Development Facilitation Team (DFT) – Review Comments

Project No: PR-2024-009956 Date: 3/19/2025 Agenda Item: #5 Zone Atlas Page: M-9

Request: Proposed site improvements for a new tenant building with a Taco Bell quick-service restaurant with accessory drive-thru on the Endcap.

Application For: SI-2024-01475 – SITE PLAN DFT

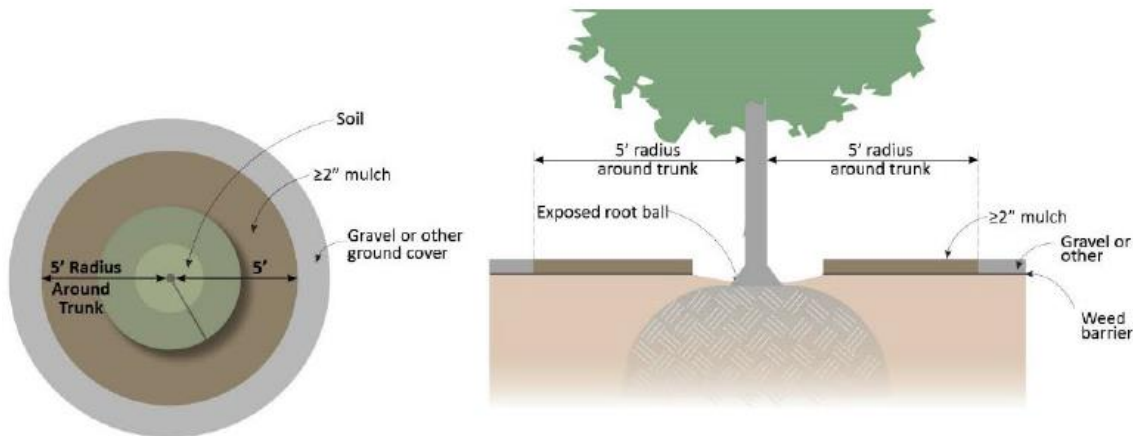
- Per 5-6(C)(5)(e) Organic mulch is required as ground cover under trees within a 5-foot radius around the tree trunk, but not directly against the trunk. In these areas, weed barrier fabric is prohibited. [The 5' radius organic mulch must be shown and called out on all tree planting details.](#) Please see the figure below from the IDO 5-6(C)(5)(e) for more clarification.

[Organic mulch noted in notes and details](#)

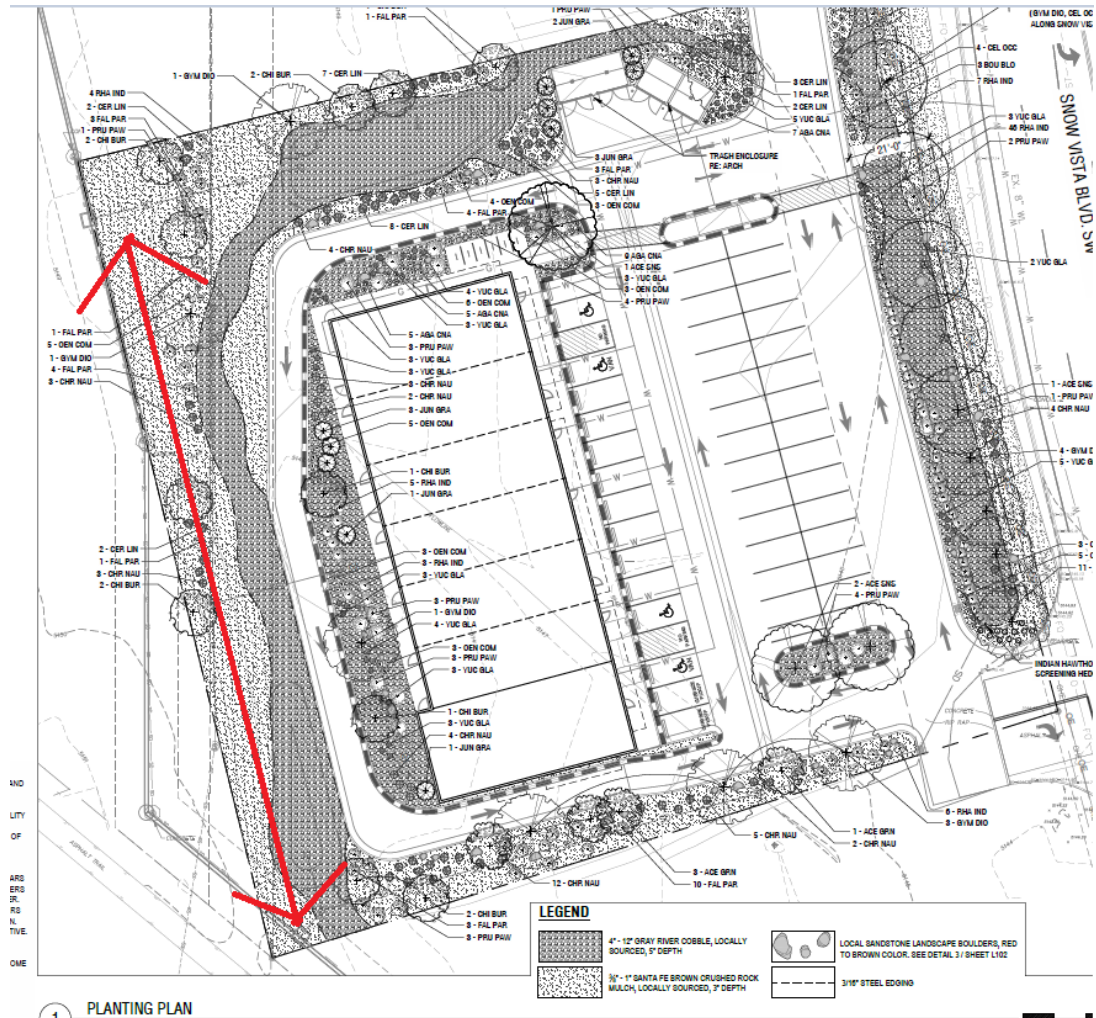
- Per 5-6(C)(7)(a) Vegetation required by this Section 14-16-5-6 shall be located the following distances in any direction from any fire hydrants, valve vaults, hose bibs, manholes, hydrants, and fire department connections:

1. Shrubs: 3 feet

2. Trees: 15 feet

Confirm compliance with this requirement Add a note for this requirement to the plan.

[Compliant](#)
